Planning Commission Staff Report

Project Type: Amended Site Development Section Plan

Meeting Date: October 12, 2020

Description: Clarkson Square, Lot A (McDonald's) ASDSP: An Amended Site Development

Figure 5: East Elevation

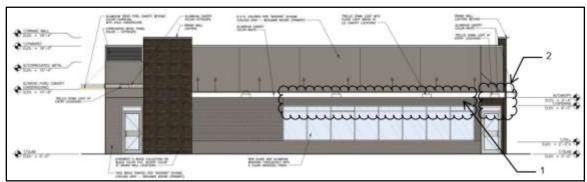
This project was reviewed by the Architectural Review Board on May 9, 2019, where it was forwarded to Planning Commission with a recommendation for approval with two (2) conditions:

- 1. Wrap the E-WOOD black color tile around all sides beneath the awning feature of all elevations where visible.
- 2. Horizontal mullions be incorporated to carry around the building.

The applicant has since fulfilled both of these conditions.

AMEND ARCHITECTURAL ELEVATION

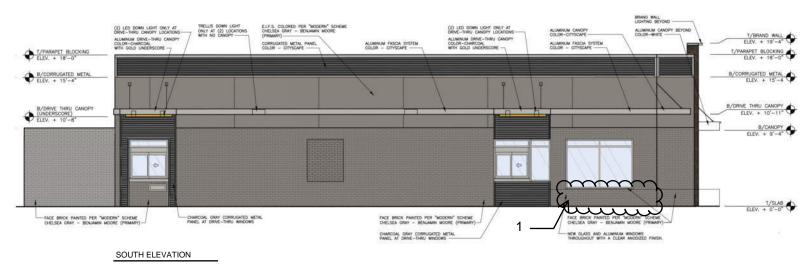
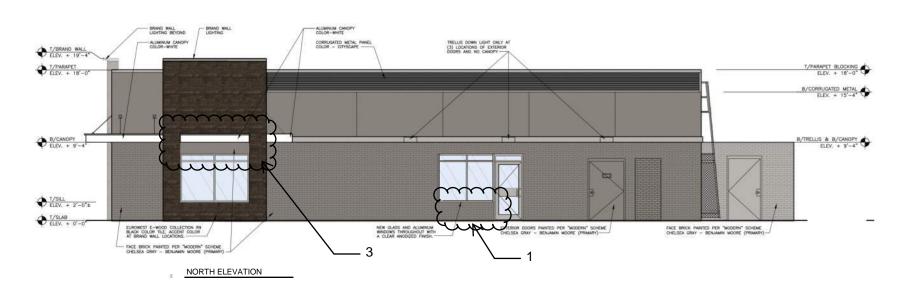
- 1. Brick infill was added to continue the horizontal datum lines across the elevation.
- 2. Brand wall tile returns at the vestibule below the canopy to appear more rigid.
- 3. Vestibule glazing height revised to match glazing height at side and front elevations.
